Addendum No. 1

2018-19 PRESSURE REGULATING STATIONS IMPROVEMENTS

PWP Bid No. WA-2019-061
January 3rd 2019

C600

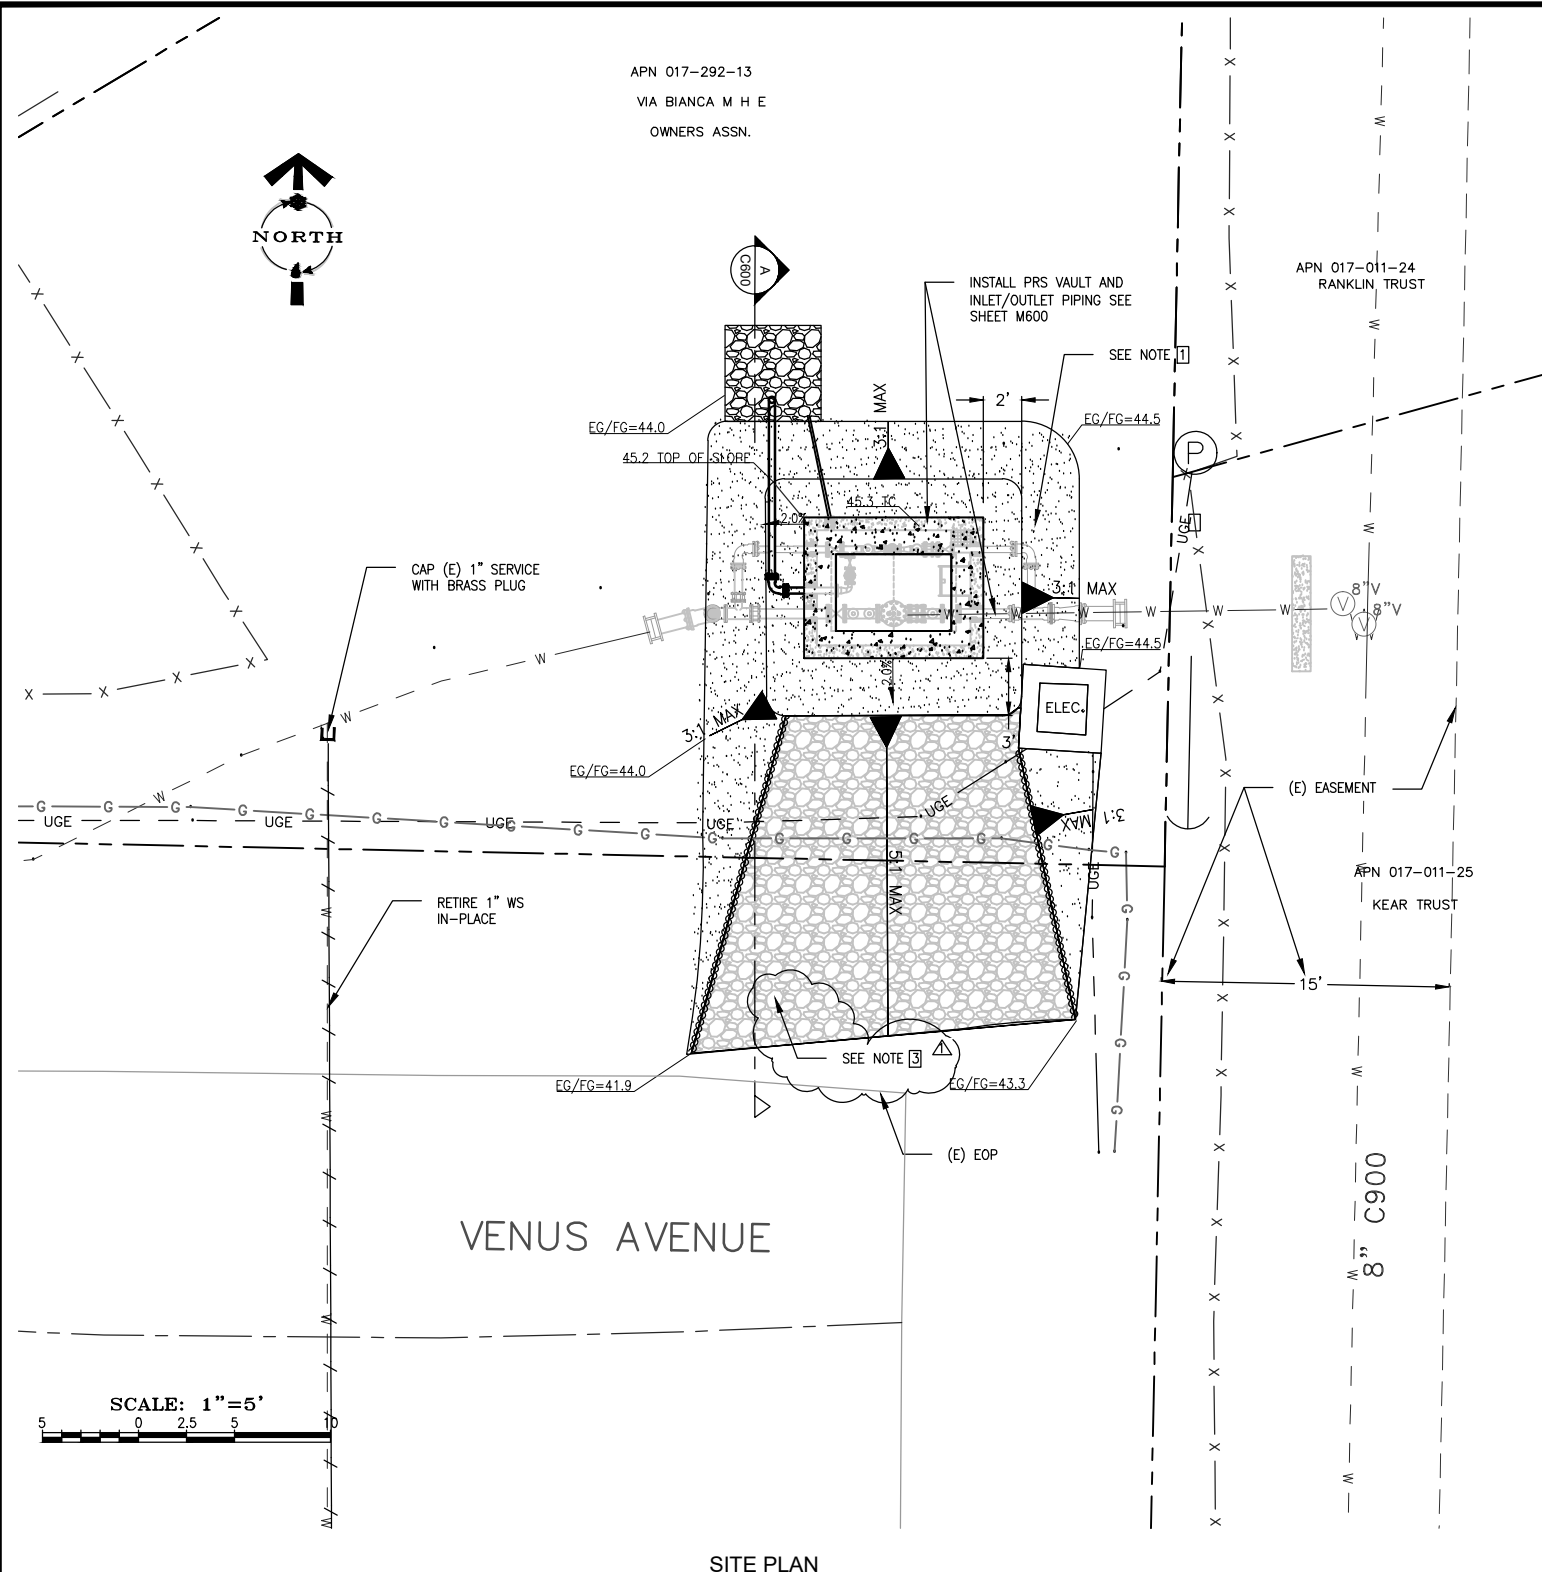
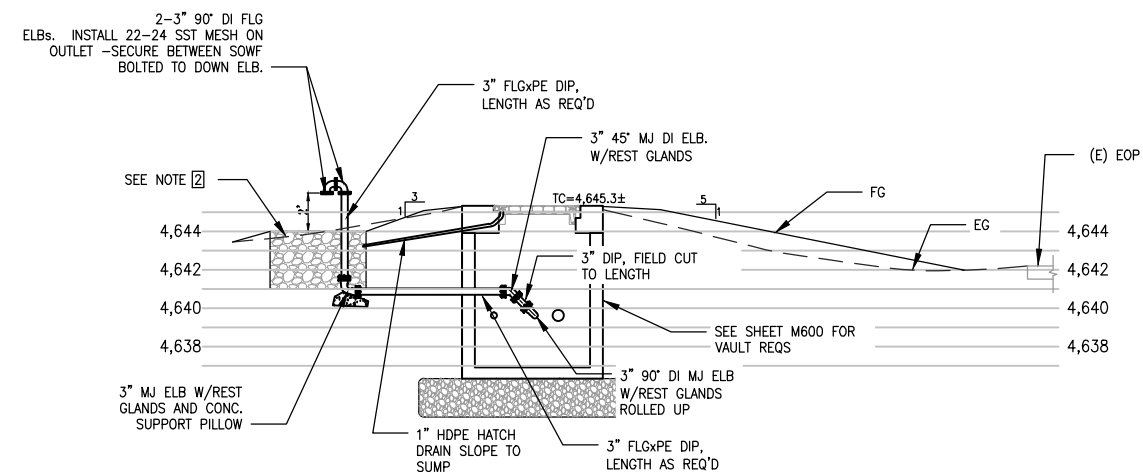
- Improvement plan Sheet C600 has been revised to add 1-1/2" crushed rock surface for the driveway area, see revised plan included with this Addendum.
- Improvement plan Sheet M400 has been corrected for the incorrect 12-inch callouts per question number 1 above.

REVISION	DESCRIPTION	BY	APP	DATE
△	ADDENDUM #1 - ADDED 1-1/2" ROCK CAP FOR LIMITS SHOWN	SWB	JB	1/2/18

M400

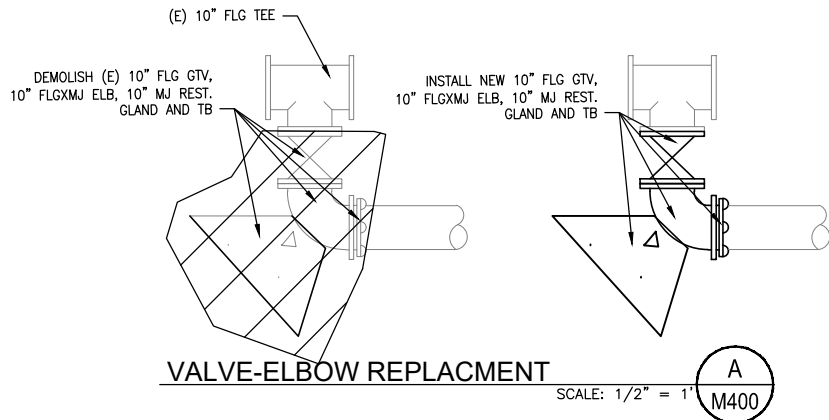
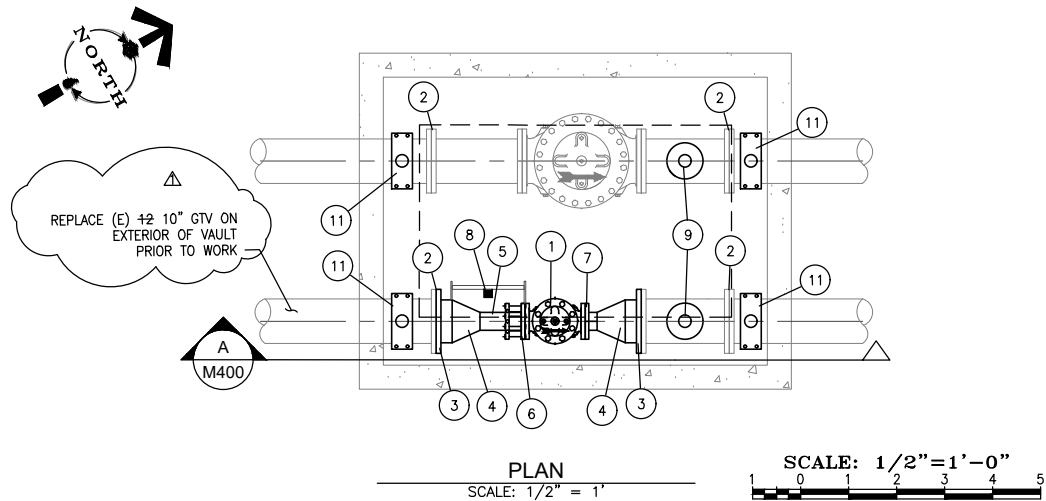
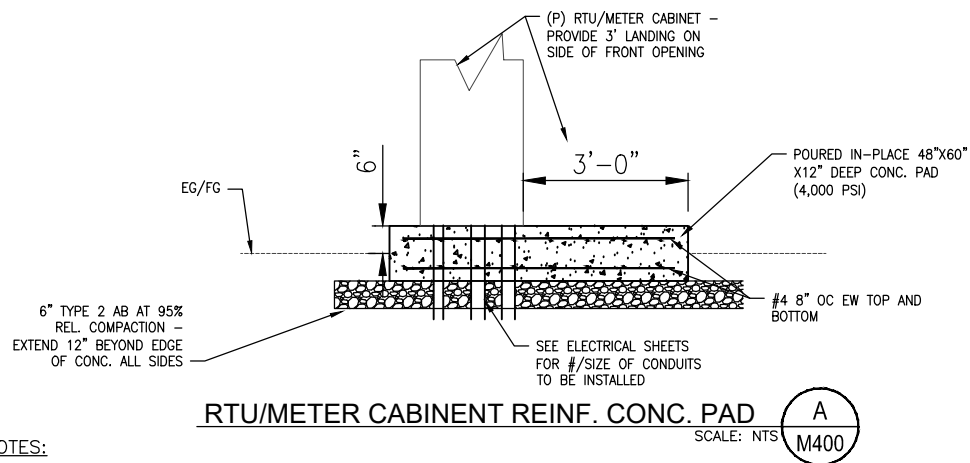
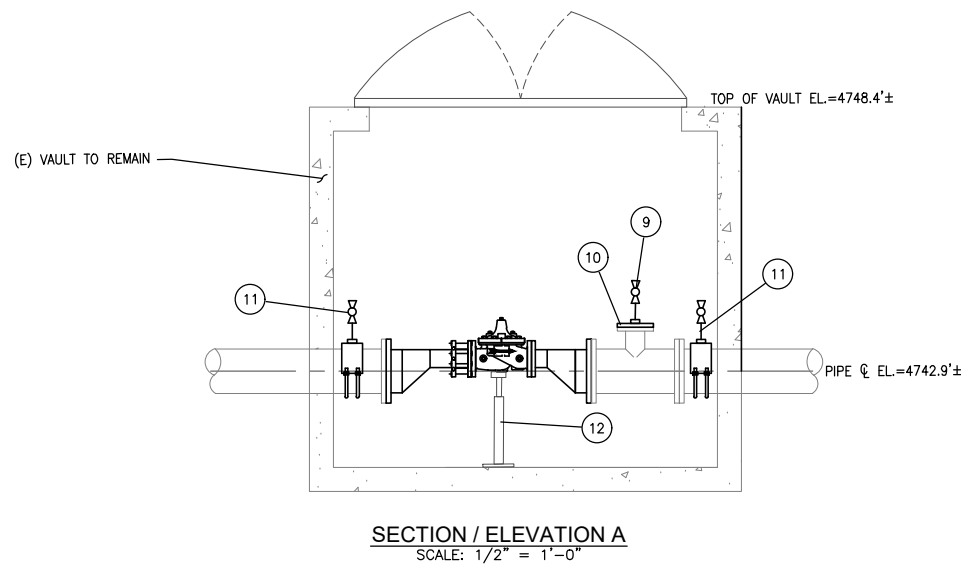
Question No. 1: Sheet M400 has contradicting call outs on existing lines as 10” and 12”. Please verify the size of both existing lines.

Question No. 2: Sheet M400 Plan View shows (3) item #2 isolation joints on existing pipe joints. Is the contractor responsible for disassembling the existing flange joints to install an isolation joint and reassemble the existing joints?

REVISION	DESCRIPTION	BY	APP	DATE
Δ	ADDENDUM #1 - CORRECTED VALVE SIZE CALLOUT FROM 12" TO 10"	SWB	JB	1/2/18

Response to Question No. 1: The exterior pipe is 10-inches adjacent to the vault and there is a 12”x10” reducer beyond the limits of work. The plan callout for “REPLACE (E) 12” GTV ON EXTERIOR....” Will be revised to “REPLACE (E) 10” GTV ON EXTERIOR...” – See Revised Plan Sheet M400 included with this Addendum

Response to Question No. 2: Yes, and coordinate this work with exterior valve replacement work to avoid multiple main outages. Do not want to have pressure on upstream pipe/valve adjacent to vault during interior pipe removal.
